AGENDA
REGULAR MEETING OF THE
WINDSOR HEIGHTS
PLANNING AND ZONING COMMISSION
Wednesday, February 26, 2025 - 5:30 PM
WINDSOR HEIGHTS COUNCIL CHAMBERS - 1133 66th ST
ZOOM: <https://us02web.zoom.us/j/7832856334>
Meeting ID: 783 285 6334

Date: February 26, 2025
To: Windsor Heights Planning and Zoning Commission
From: Trey Rouse
Subject: Site Plan: University Avenue and 63rd Street Corner

RE: Site Plan: 6500 Hickman Road – Windsor Court Apartments | Review Comments

WINDSOR COURT APARTMENTS
6500 HICKMAN ROAD
WINDSOR HEIGHTS, IOWA

C-101 - LAYOUT SHEET

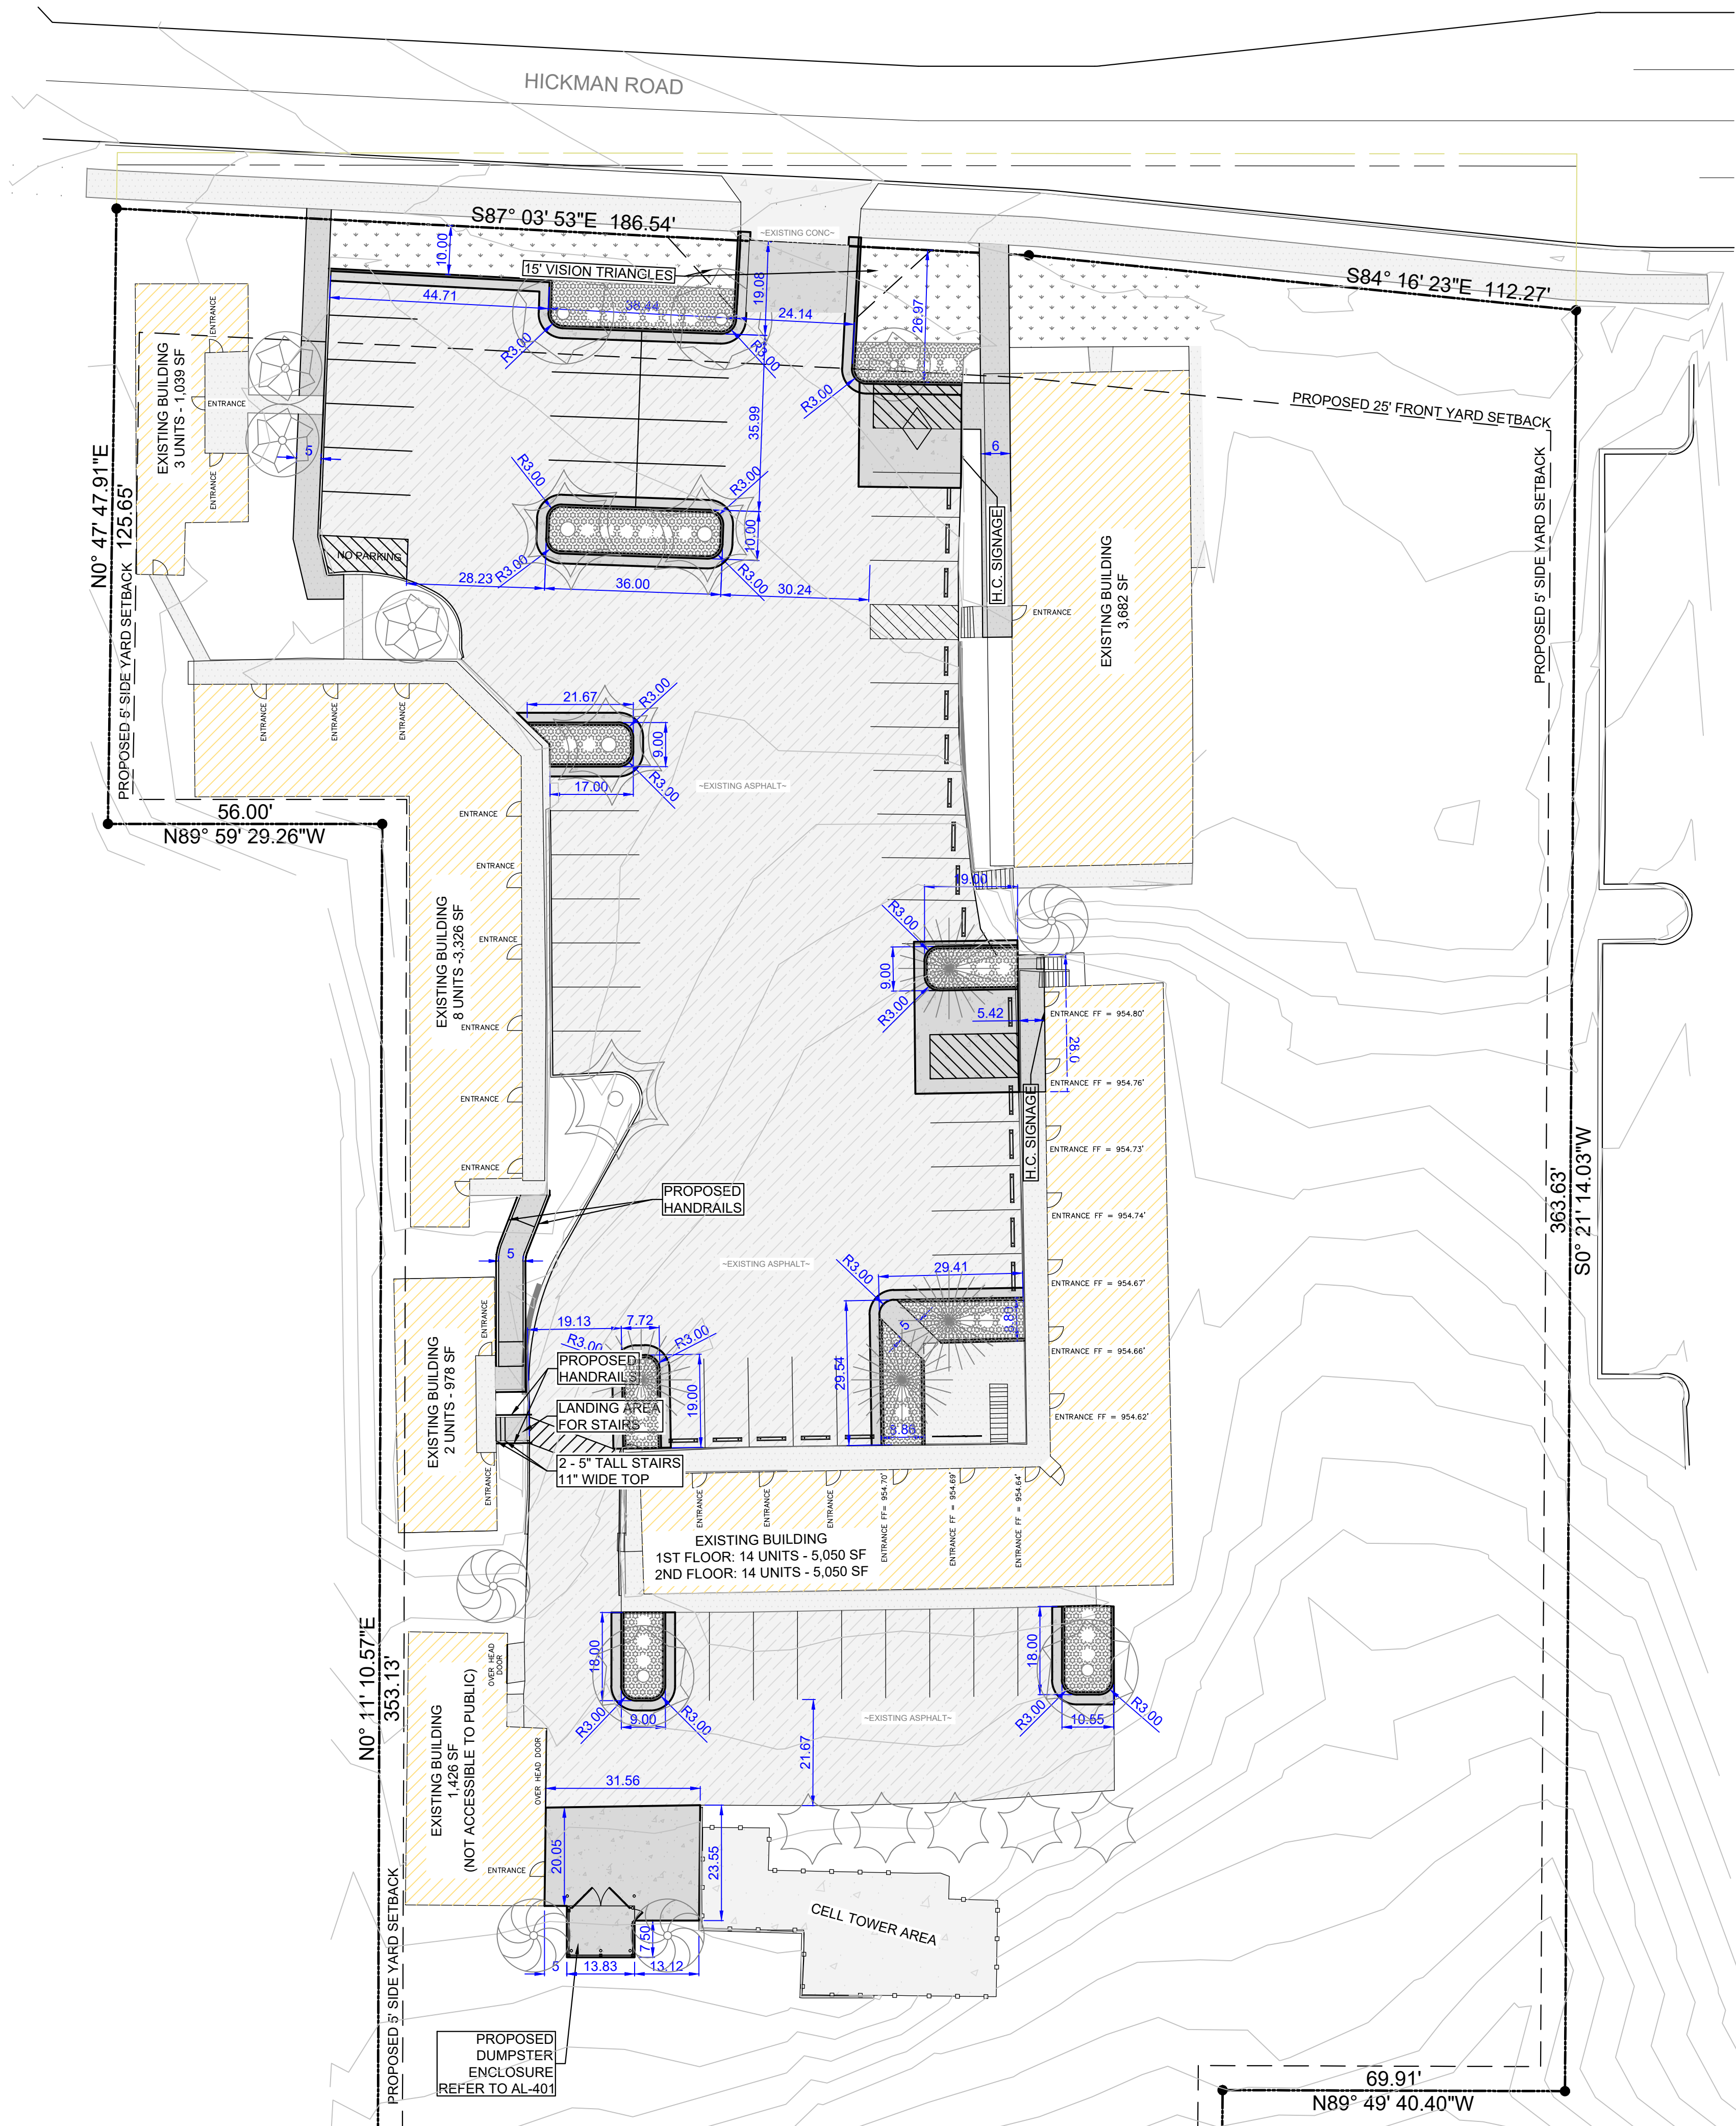
1. Code 170.07 – Buildings must have accessible routes of entry. Accessible routes are shown, but the city is concerned with the ramp design for the 978 SF building not meeting ADA. The handrail must extend 12” past the ramp and have 5’ x 5’ landings at top and bottom. With an 8% maximum slope for ramps, we recommend steepening and shortening the proposed ramp to provide space for the ADA required handrail and landings. Ramps, landings & handrails have been revised to meet ADA requirements.

2. Code 170.07 – Pedestrian corridors should be indicated from any public street to all proposed principal buildings. While there are pedestrian corridors connecting to all buildings now, the city noticed the existing stairs on the 978 SF building are not meeting IBC 1009.8 Stairway landings: “There shall be a floor or landing at the top and bottom of each stairway”. The current design has the stairs spilling out onto the parking lot. Stairway has been revised to include a ADA landing at bottom as well as handrails. Handrail detail has been added to Layout Sheet C-101.

C-701 - LANDSCAPING SHEET

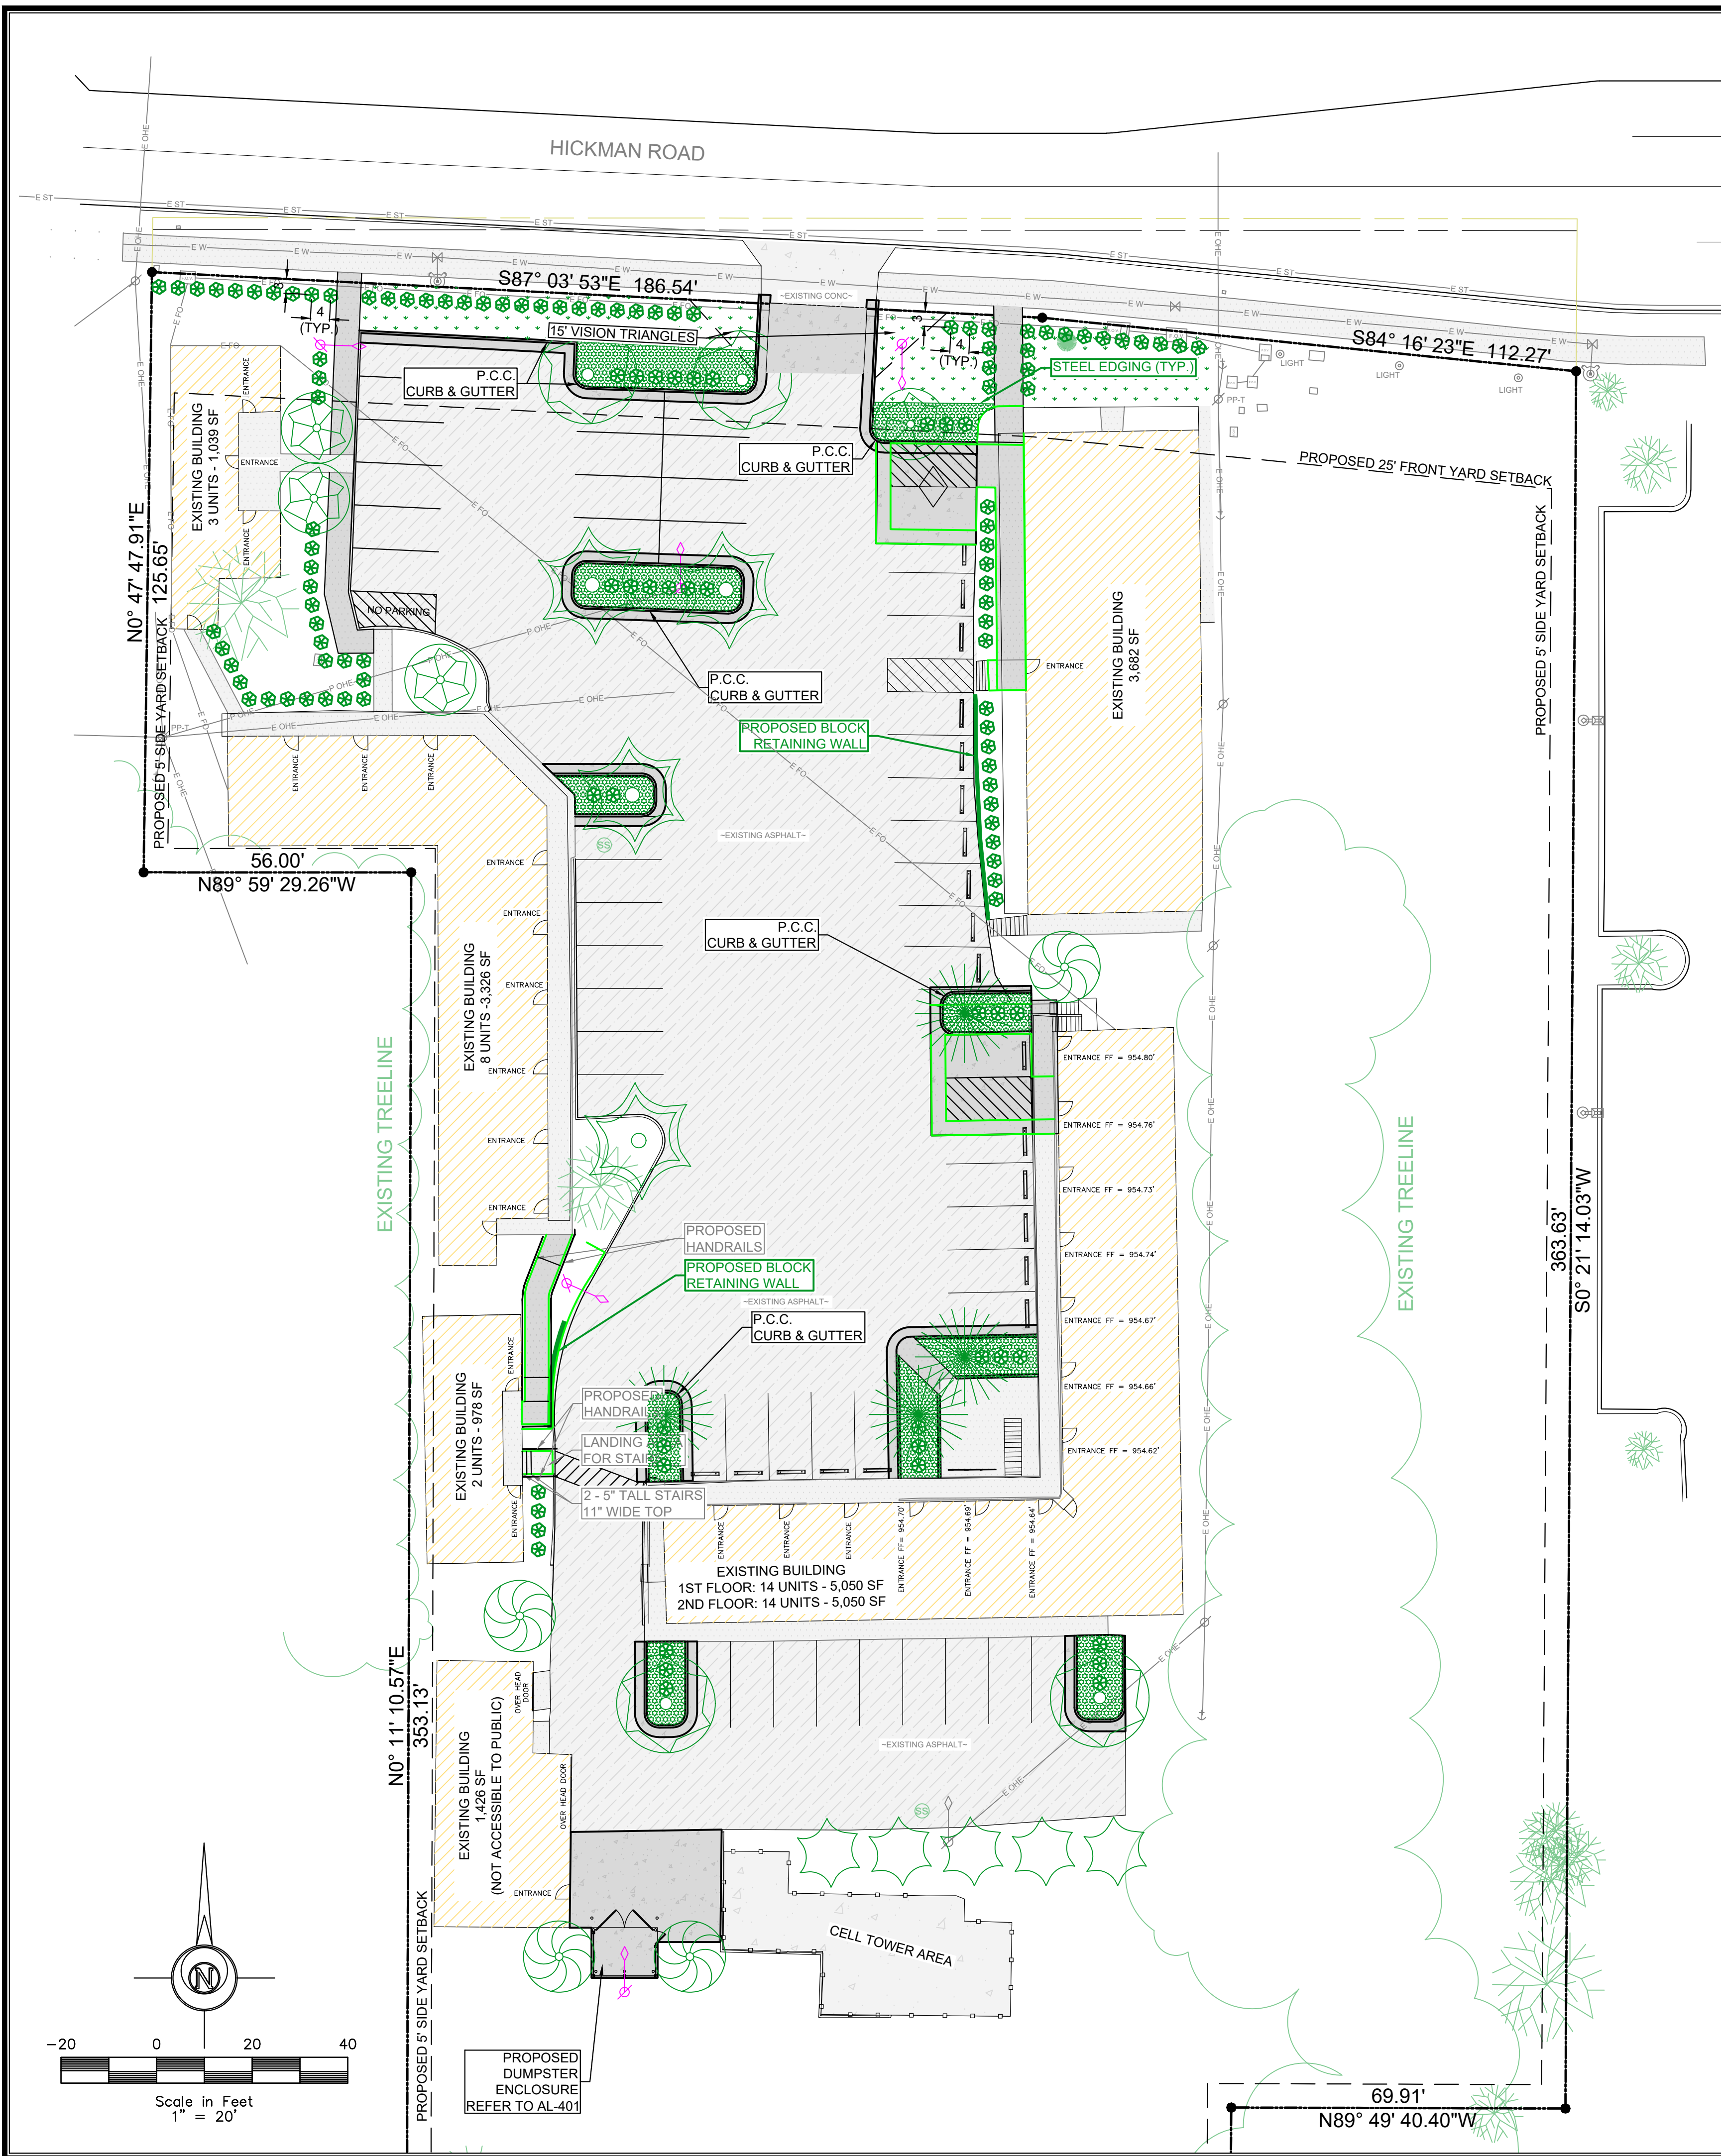
a. 1 Tree/2,000 sq. ft. of pervious surface is required. This requirement is 25 total trees and the proposed site only provides 16. Please address and add 9 more trees to the site. A total of 25 trees are now being shown.

b. 5 Shrubs/2,000 sq. ft. of pervious surface is required. This requirement is 127 total shrubs and the proposed site only provides 73. Please address and add 54 more shrubs to the site. A total of 127 shrubs are now being shown.
